**Petition No. 1328
Interrogatories
October 11, 2017**

ABINGTON
SOLAR
481 MASHMOQUET ROAD
POMFRET, CT 06259
TOLLAND COUNTY

Exhibit AS-38

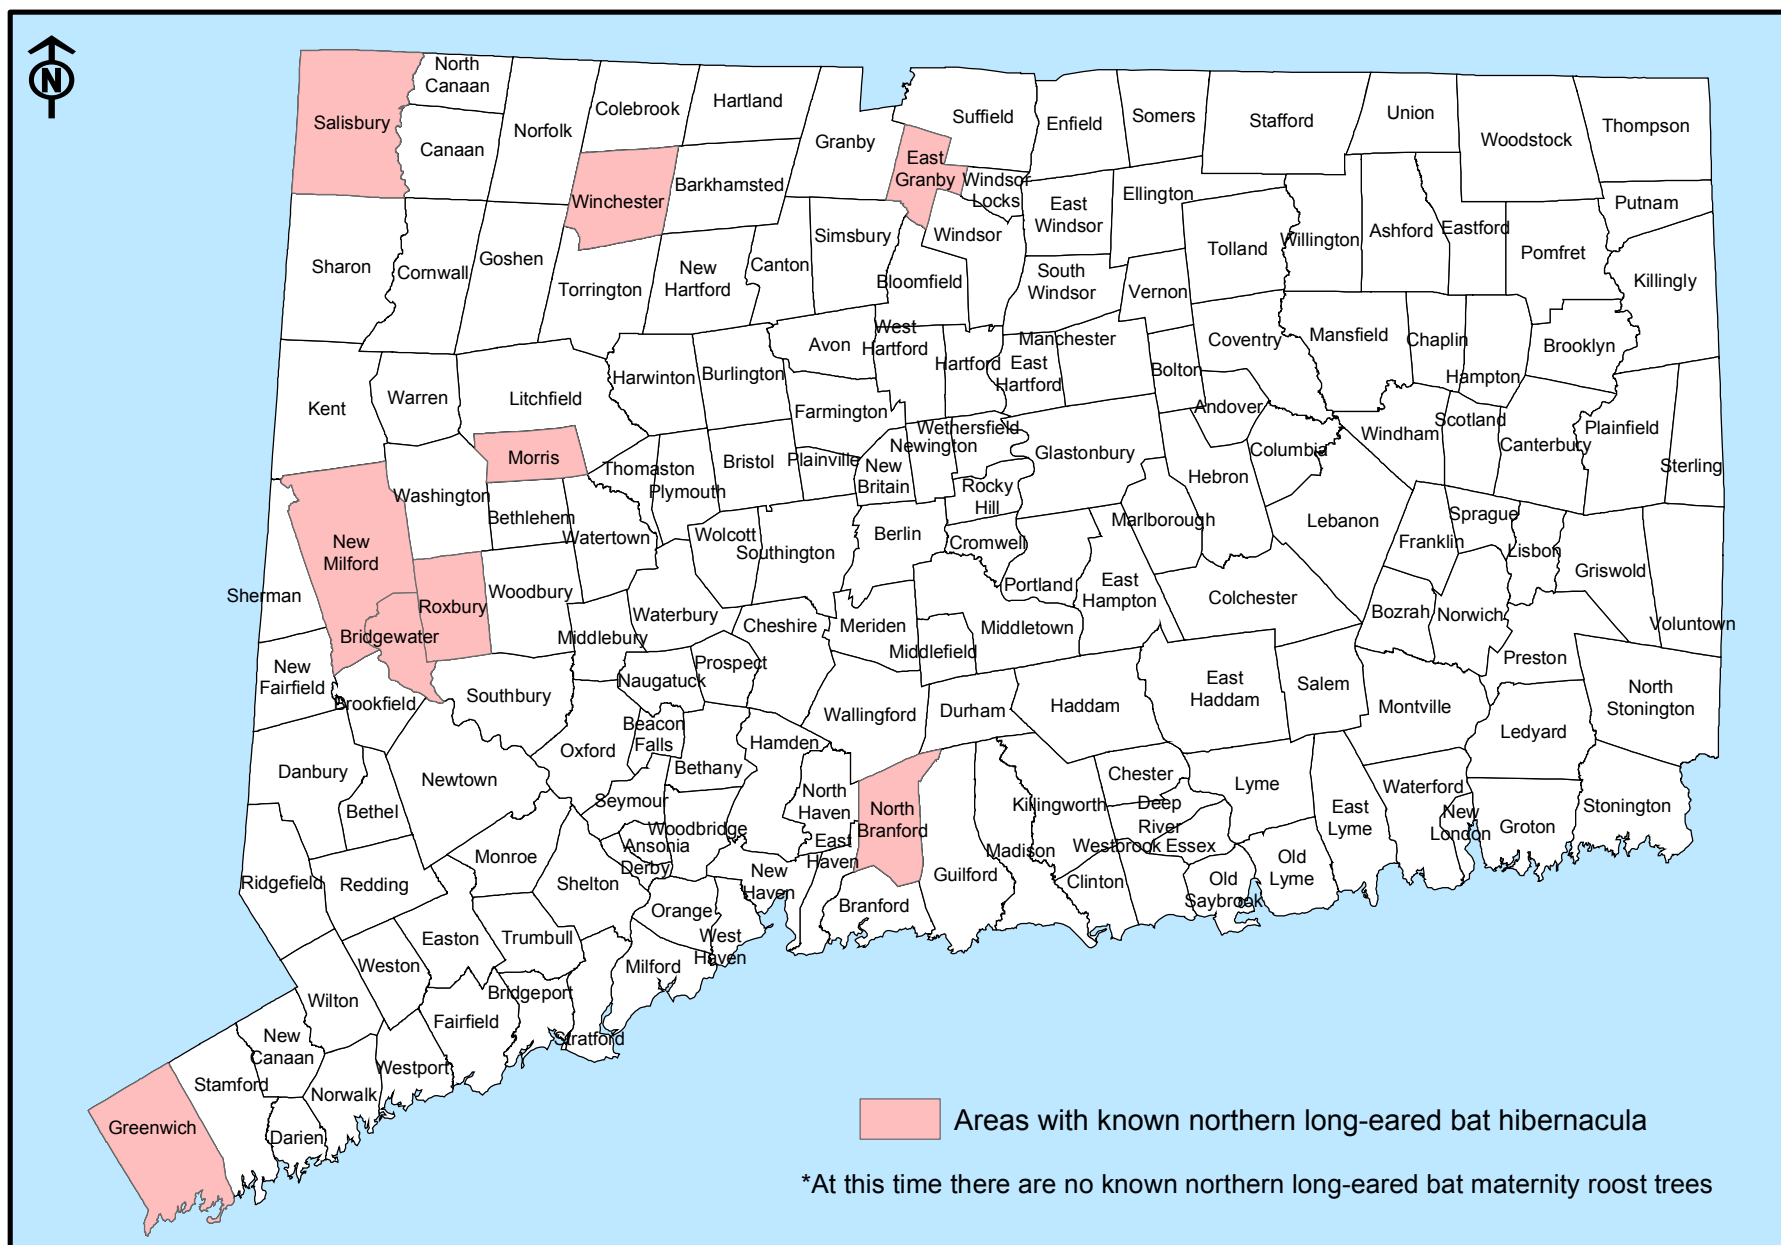
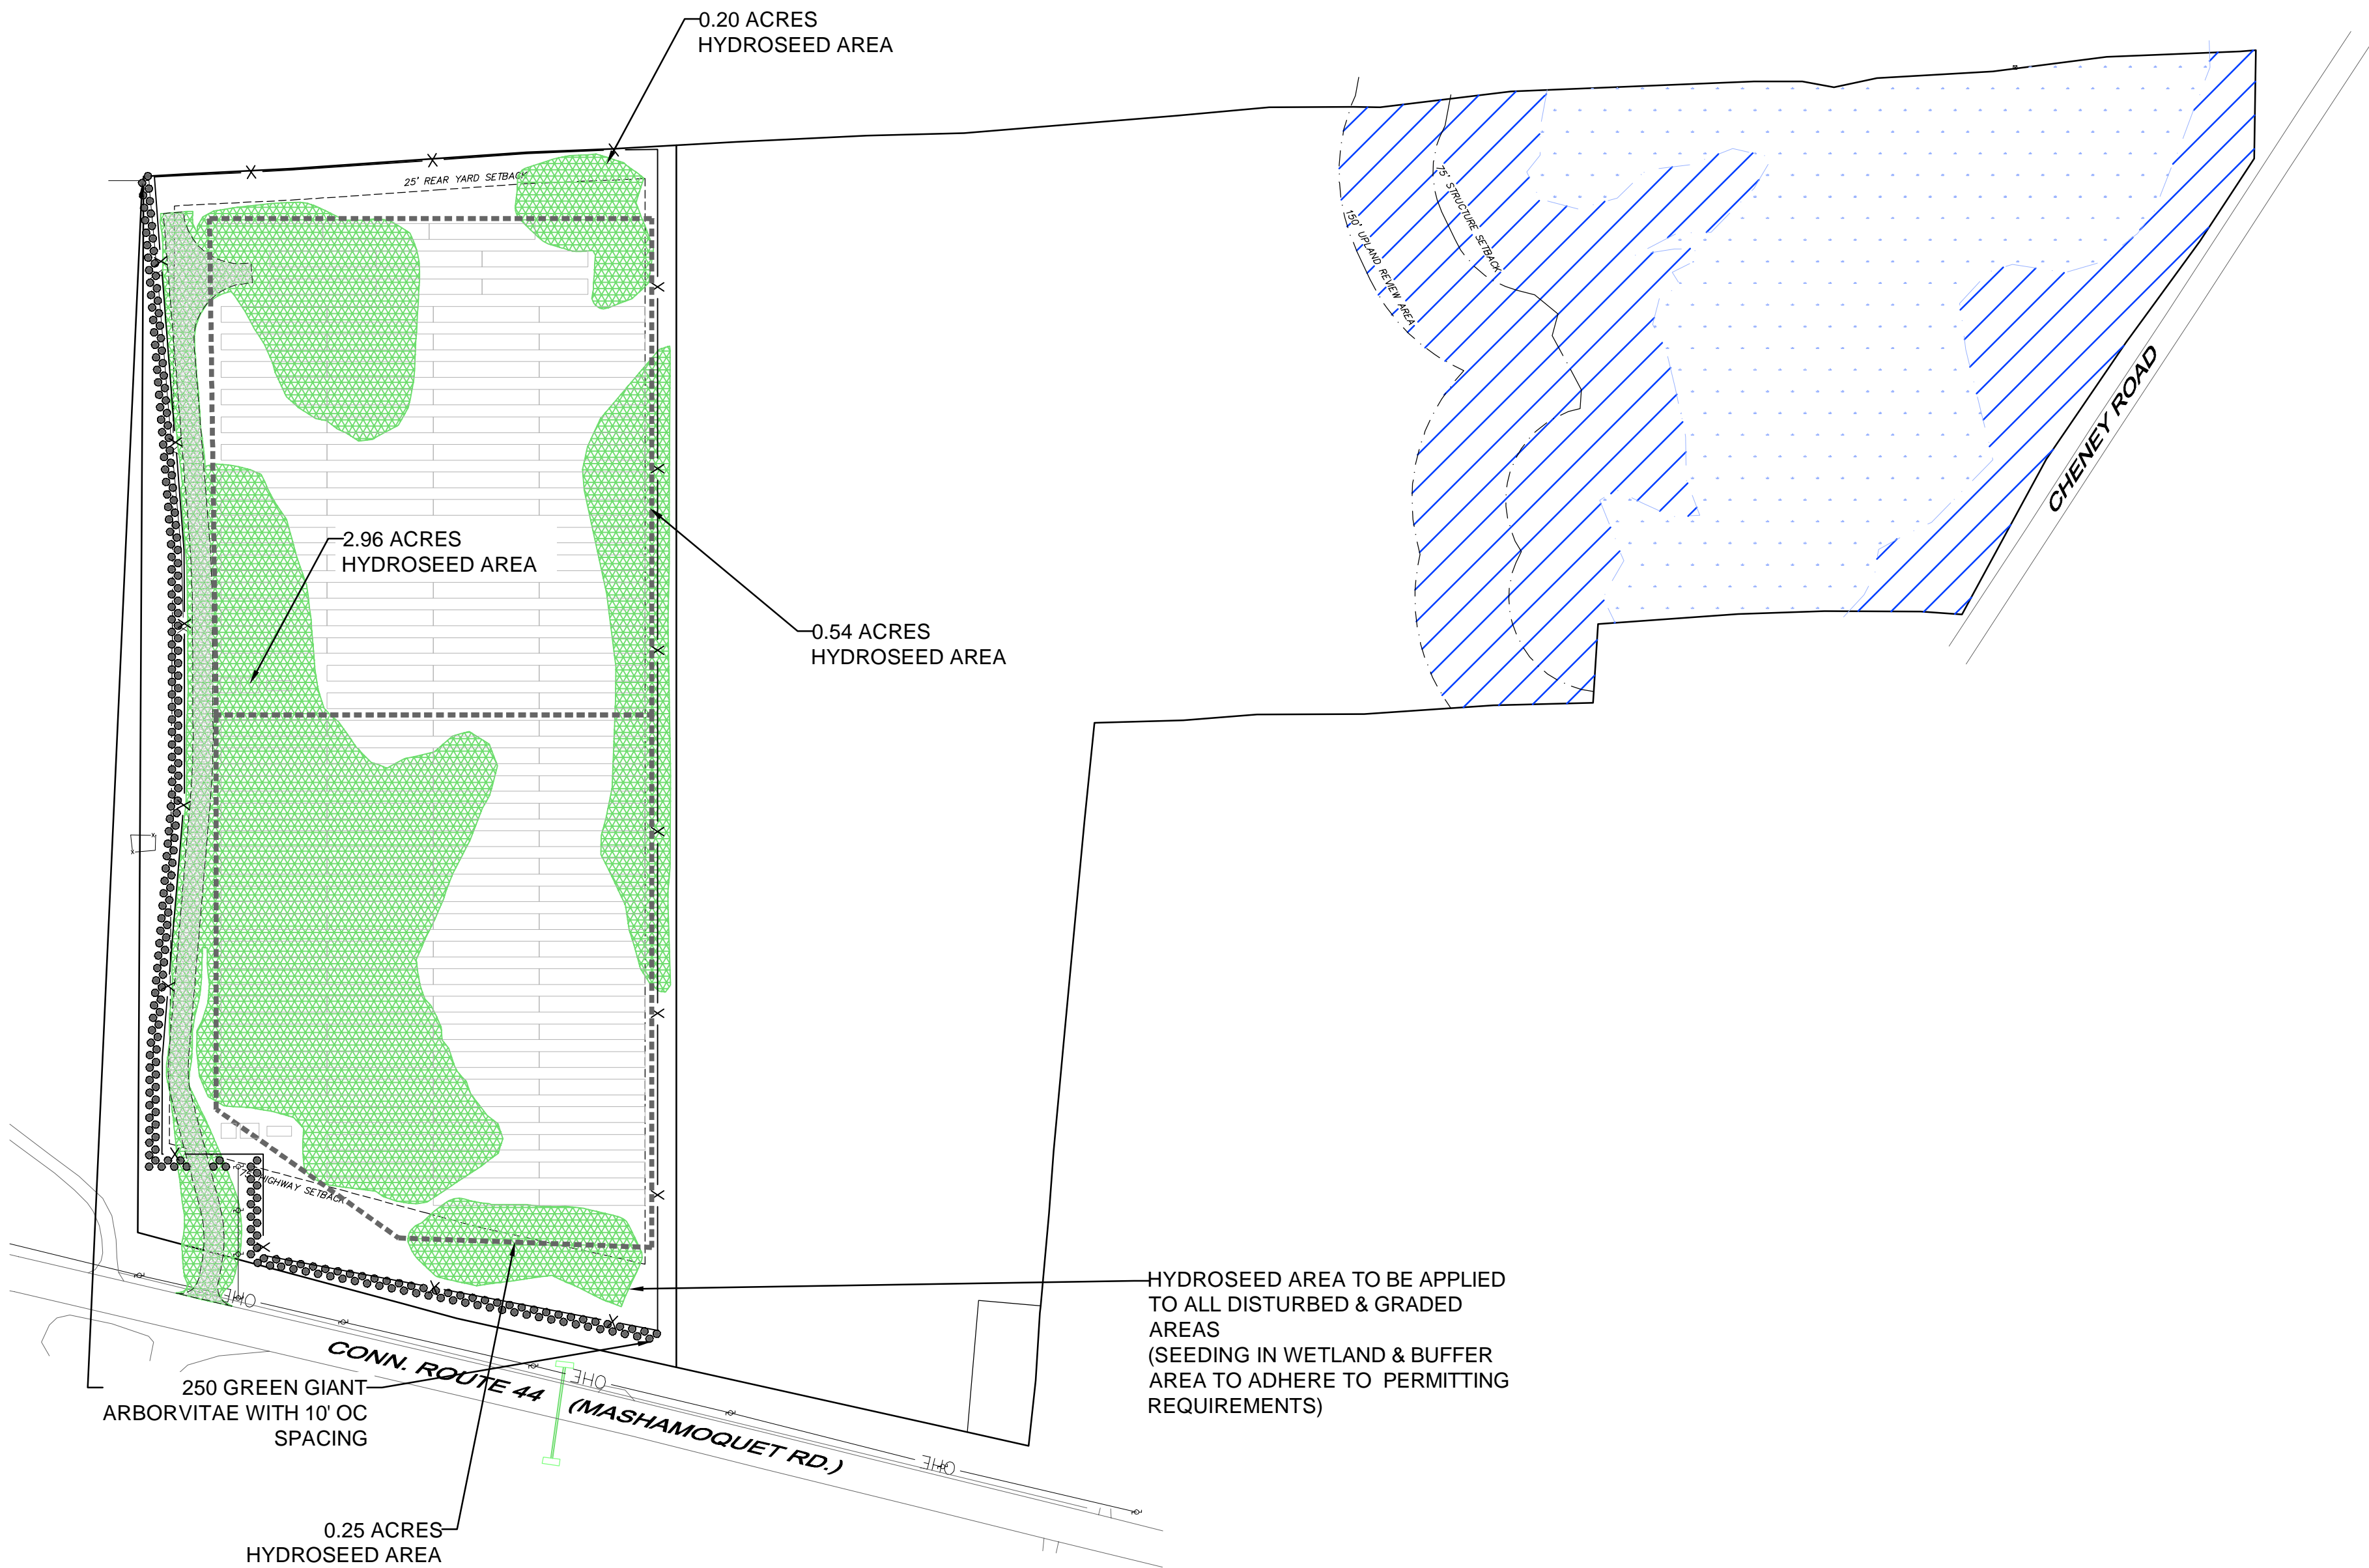
CSC AS 38. Would any proposed tree clearing occur within .25 miles of a known Northern Long-eared Bat hibernaculum?

No. It is not anticipated that there is any Northern Long Eared Bat (NELB) hibernacula, based on the Feb 1, 2016 NLEB areas of Concern in Connecticut. The removal and cutting of all trees greater than 3" in diameter, is prohibited under a time of year restriction by the USFWS during the bat active season from April 15th through October 31st, for any project within 1 mile of a designated hibernacula. Depending on the time of approval for the project, the developer will attempt to adhere tree removal outside these clearing dates, if trees need to be cleared within that timeframe, a bat hibernacula survey will be performed and consultation with the USFWS will occur. Please reference Exhibit AS-38 for a map of Northern long-eared bat areas of concern in Connecticut.

OVERALL
LANDSCAPE PLAN

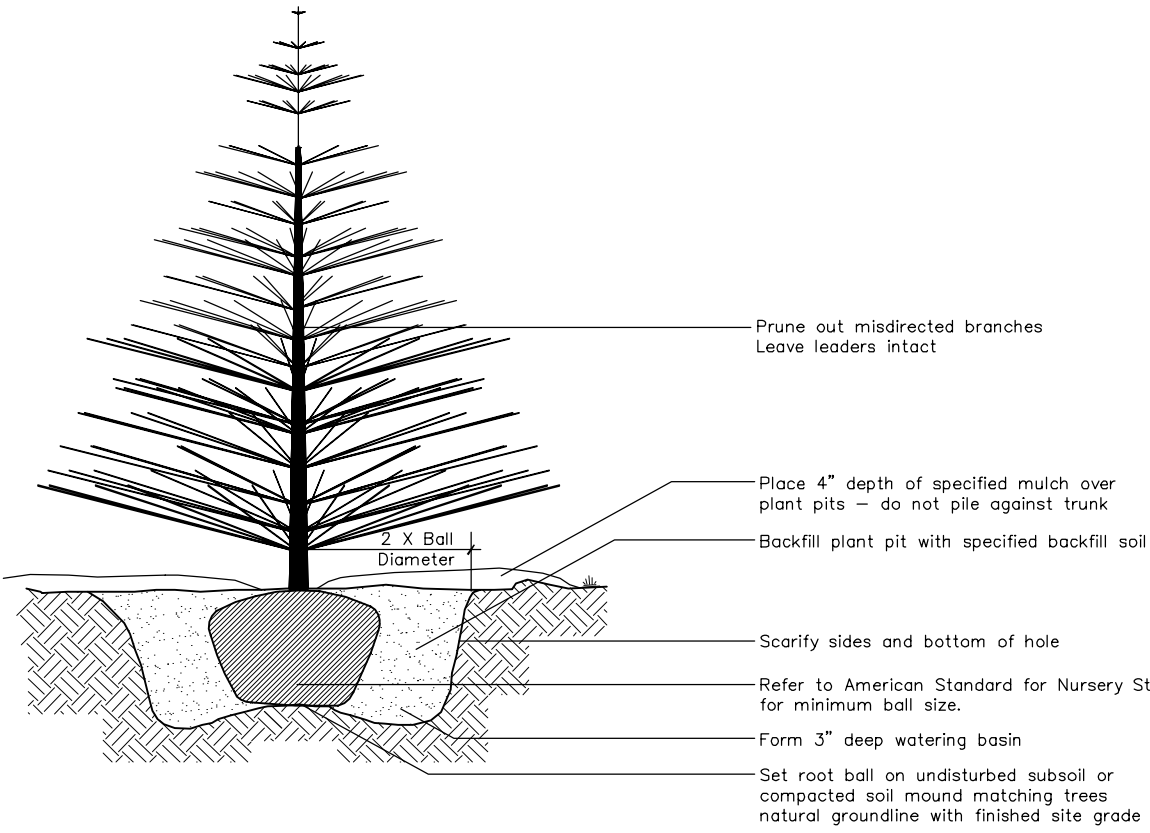
CSC AS 41. Page 12 of the petition states that views of the solar facilities from the south, north and west would be screened by trees and natural vegetation that would be left in place; however, the site plans and Key Observation Point Plans included show that most or all vegetation along Mashamoquet Road and along the western boundary would be within the facilities project area and, therefore, removed. Please provide information as to where the robust buffer of trees and vegetation would remain to provide screening of the facilities.

CSC AS 42. Page 12 of the petition discusses planting trees to screen the views of the facilities from the property to the east; however, the Overall Landscape Plan shows only areas of hydroseeding. Where and what type of vegetation would be installed. Please provide an updated landscaping plan depicting these areas.

The statement in the petition regarding the screening was an error. It should've read that the views of the solar facilities from the east and north would be screen by trees and natural vegetation that would be left in place. In order to enhance the screening from the existing vegetation, Petitioner is proposing to install screening vegetation as shown in the landscape plan attached as Exhibit AS-41-42.

Please refer to the landscape plan attached as Exhibit AS-41-42. Approximately 250 Green Giant Arborvitaes (*Thuja plicata*) will be installed along the west and south fence line planted 10' on center, staggered in two rows to create a robust screening hedge. The Green Giant Arborvitaes are deer resistant as well.
